PLANNING COMMISSION AGENDA ITEM
CITY OF SHORELINE, WASHINGTON

AGENDA TITLE: Continued Public Hearing on Town Center Development Code
DEPARTMENT: Planning and Development Services
PRESENTED BY: Joseph W. Tovar, FAICP, Director
Paul Cohen, Senior Planner

Attachment 2 - Updated Proposed Town Center Development Code, dated 6/23/11
(Exhibit 30)

Figure 1. 20.92.020

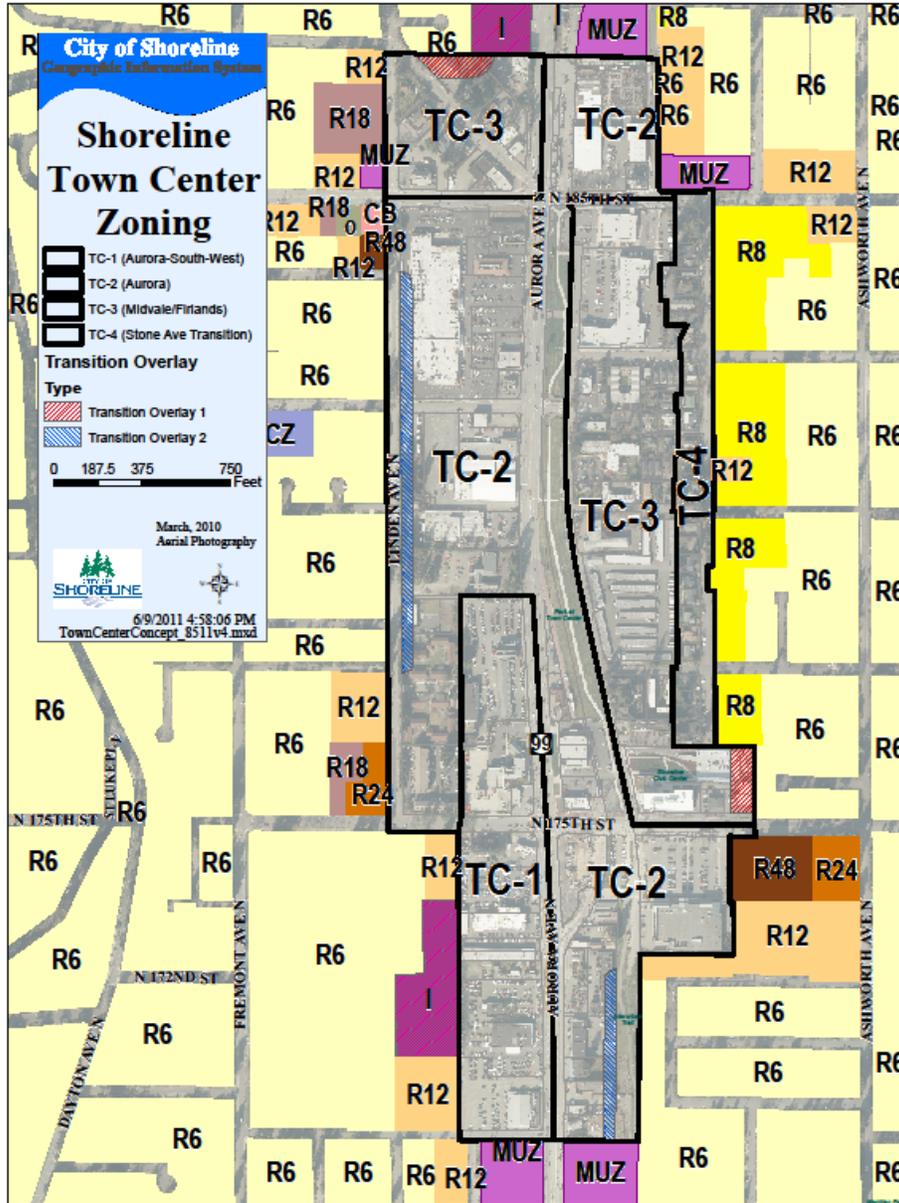
- Comment [p5]: SE Corner -Transition Overlay 2 adjusted west off SCL.
- Comment [p6]: New Map with Transition Overlays 1 and 2
- Field Code Changed

20.92.030 Street Types and Pedestrian Circulation.

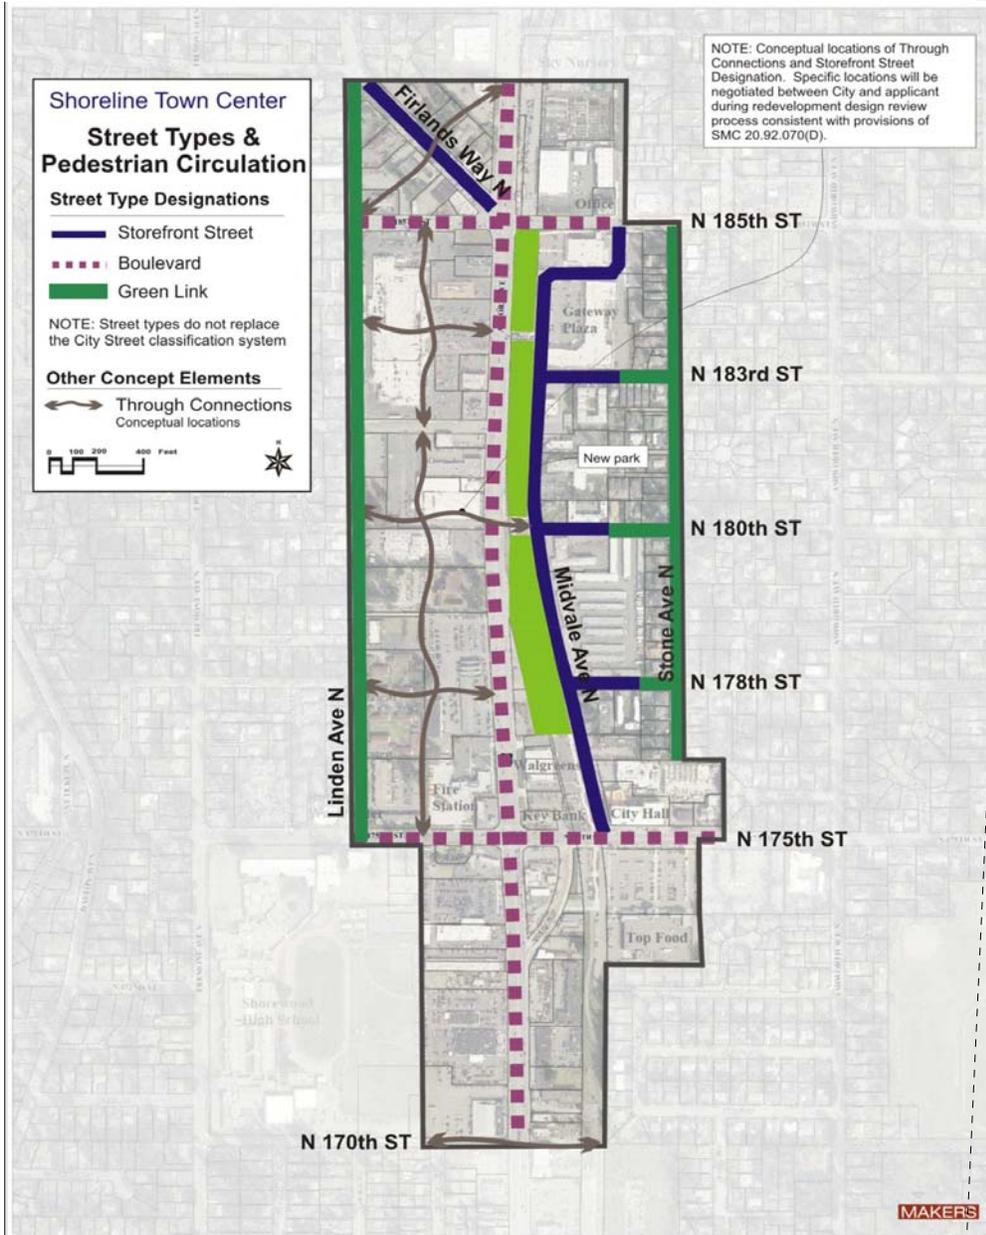
Comment [p15]: Will be revised to extend Storefront Streets to Stone Avenue. Mid-block street abutment of two different street sections do not work.

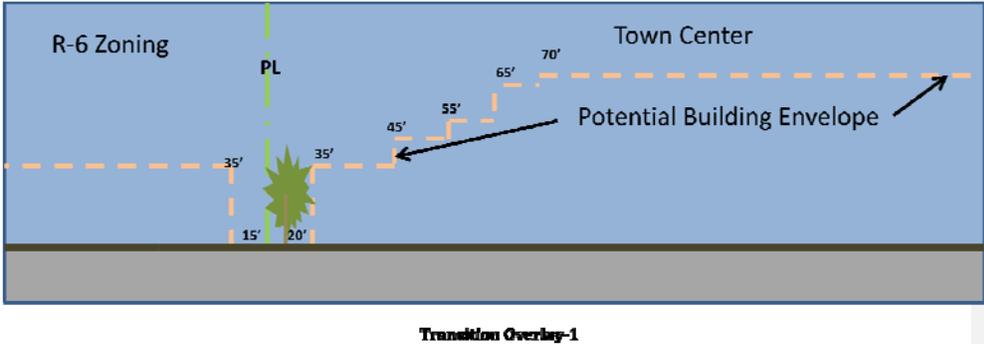
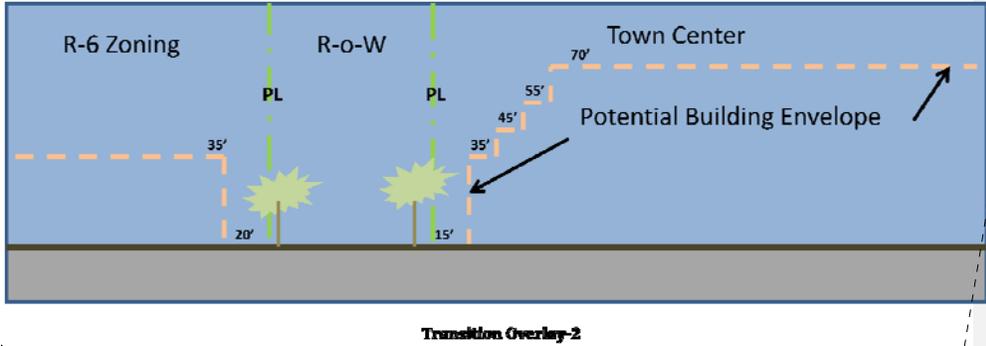
2. Transition Overlay-1 is 100 feet in depth adjoining R-4 or R-6 zoned property lines. From the adjoining property line, development requires 20 feet of Type I landscaping / building setback, limits building height to 35 feet for 30 more feet of setback and then each additional 10 feet of building height requires 20 more feet of setback until the maximum building height of the underlying zone is obtained.

Comment [j16]: Revised Potential Revision #9

3. Transition Overlay-2 is 50 feet in depth adjoining Rights-of-Way across from R-4 or R-6 zoned property lines. From the Rights-of-Way line, development requires 15 feet of Type II landscaping / building setback, limits building height to 35 feet for 10 more feet of setback, and then each additional 10 feet of building height requires 10 more feet of setback until the maximum building height of the underlying zone is obtained.

C. ~~Street~~ Corners ~~Sites~~

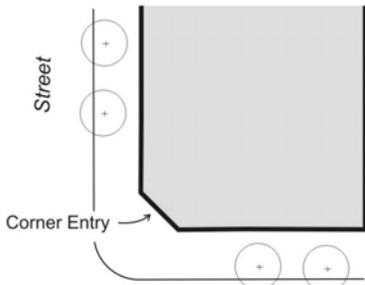
1. All development proposals located on street corners ~~and Through-connection~~ sites shall include one of the following three design treatments on both sides of the corner.

Comment [p30]: Added because a Trough-connection will create corners.

2. Parking lot landscaping

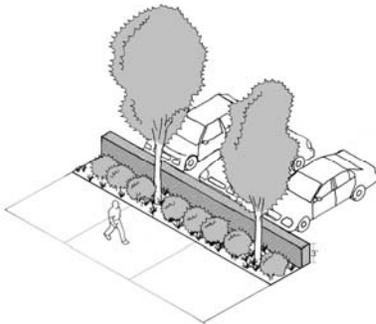
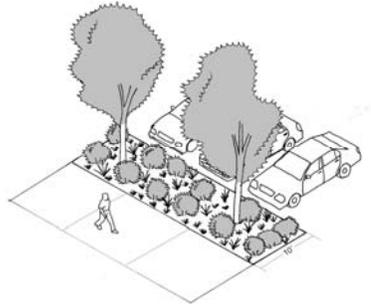
- a. Provide a 5-foot wide, Type II landscape that incorporates a continuous masonry wall between 3 and 4 feet in height. The landscape shall be between the public sidewalk or residential units and the wall (see SMC 20.50.460 for details); or
- b. Provide at least 10-foot wide, Type II landscaping.
- c. Outdoor vehicle display areas are not required to landscape with trees or shrubs. Transparent security fencing is permitted up to 8 feet. Fencing shall be made of metal other than chain link, razor, barbed, or cyclone material.
- d. Trees shall be placed interior to parking lots at a ratio of one every 10 parking spaces in curbed planters with a minimum dimension of 5 feet.
- e. All parking lots shall be separated from residential development by the required setback and planted with Type I landscaping.

Comment [p41]: Potential Revision #21A or

Comment [p42]: Potential Revision #21B
